**MONTGOMERY COUNTY  
PLANNING COMMISSION**

Re: MCPC #18-0023-001  
Plan Name: 314 River Road  
(2 lots/2 du on approximately 0.51 acres)  
Situate: River Road (E); Waverly Road (S)  
Township of Lower Merion

We have reviewed the above-referenced subdivision and land development plan in accordance with Section 502 of Act 247, "The Pennsylvania Municipalities Planning Code," as you requested on January 26, 2018. We forward this letter as a report of our review.

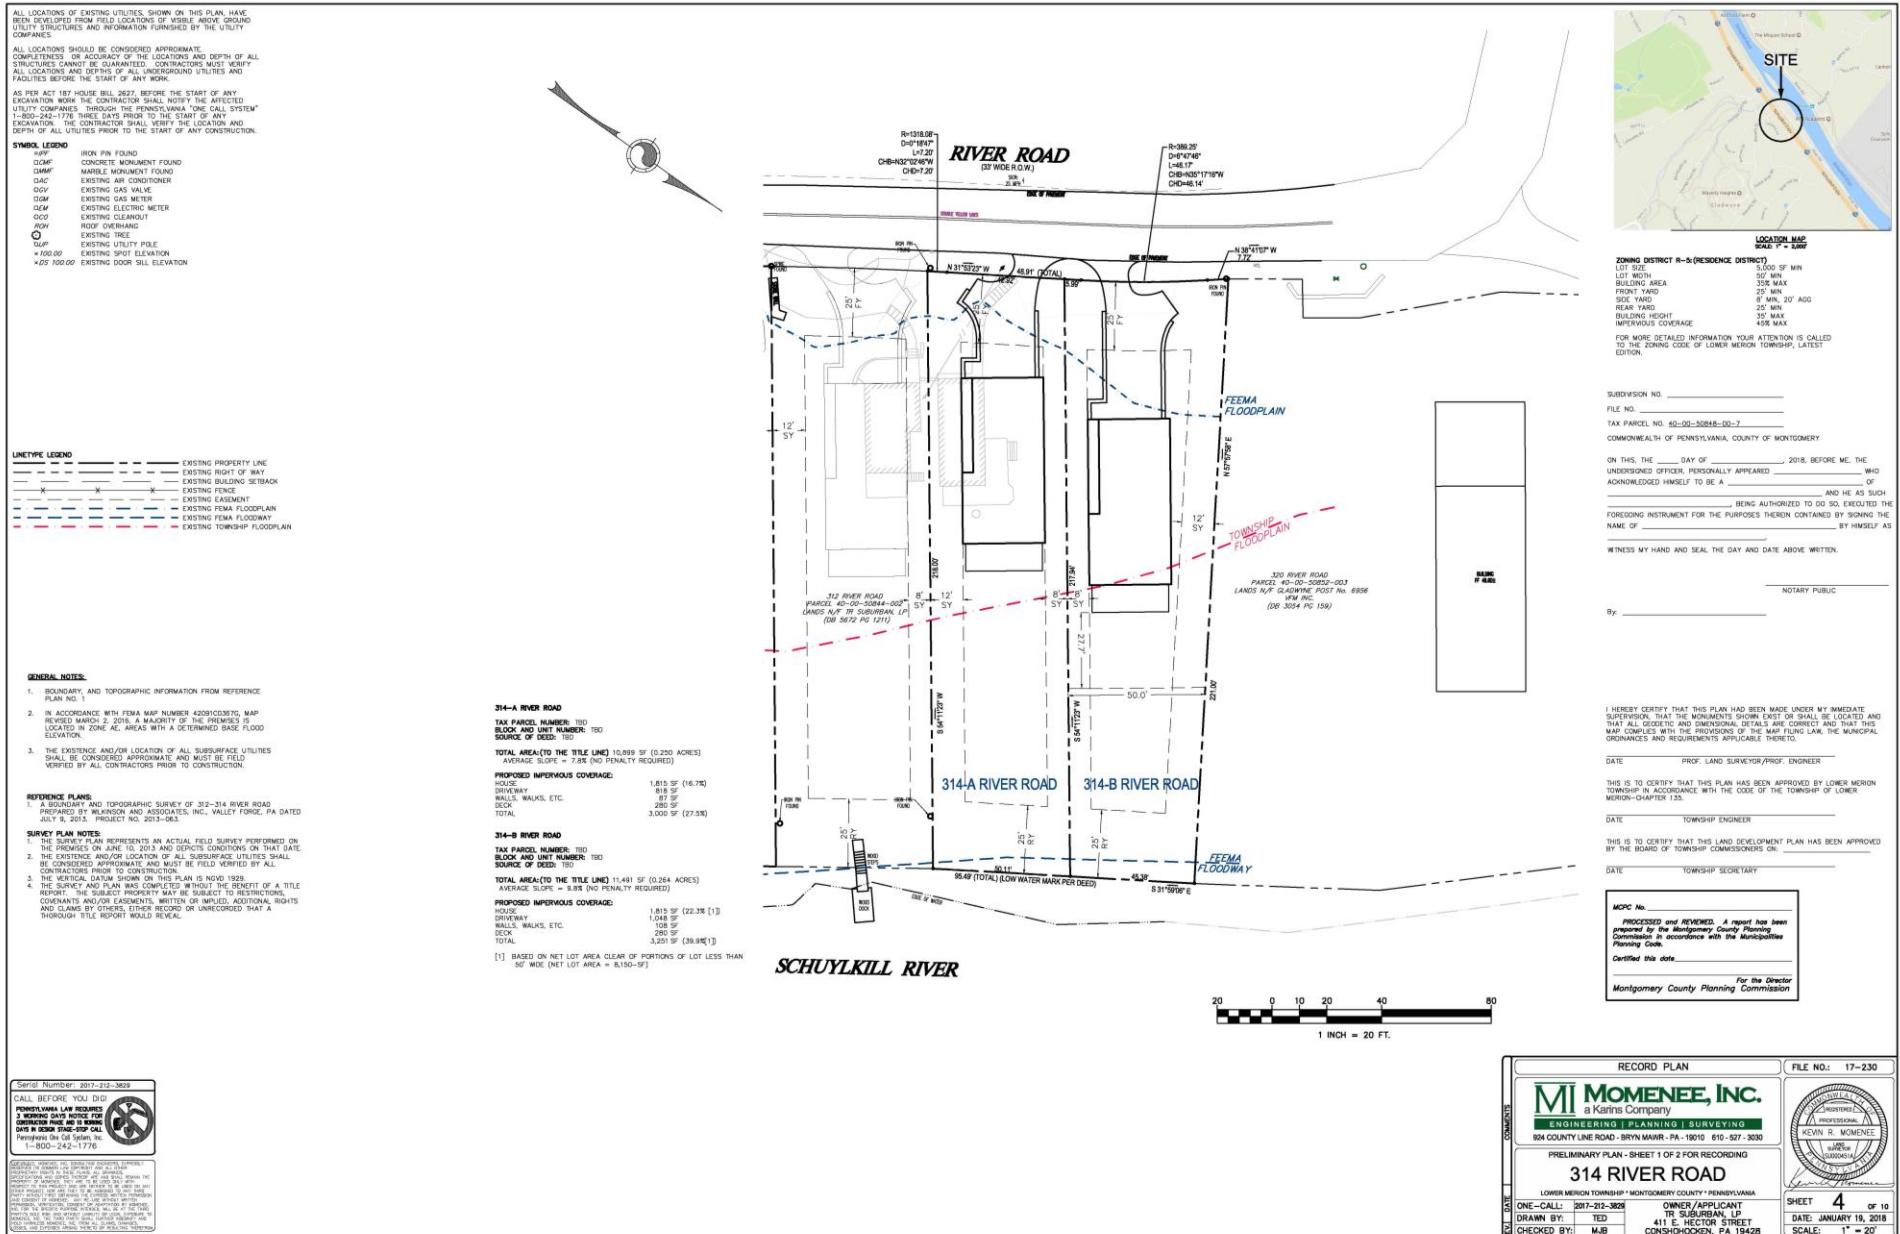
According to Sheet 6 of 10, underground stonebeds are proposed to be installed on each of the new lots to infiltrate stormwater runoff from the roof area on each lot. These stormwater management facilities are located within the floodplain and are, therefore, likely to be flooded. These facilities should, therefore, be designed and installed so as to avoid excessive siltation during flood events which could cause the infiltration system to become clogged.

Sheet 6 of 10 also shows a 20 linear foot gabion level spreader located within the floodway. This facility should be designed and installed to withstand floodway forces. In addition, the level spreader should be inspected regularly to identify any damage and repairs needed to ensure its proper operation.

The proposed driveways on 314-A and 314-B River Road are shown widening from approximately 10 feet at the property line to approximately 25 feet at the edge of pavement with River Road. The proposed driveways are shown touching at the edge of pavement of River Road. We encourage the applicant to narrow the driveway openings at the edge of pavement and provide some separation between the two proposed driveways which will allow for visual definition of the two driveways and reduce the amount of impervious surface proposed.
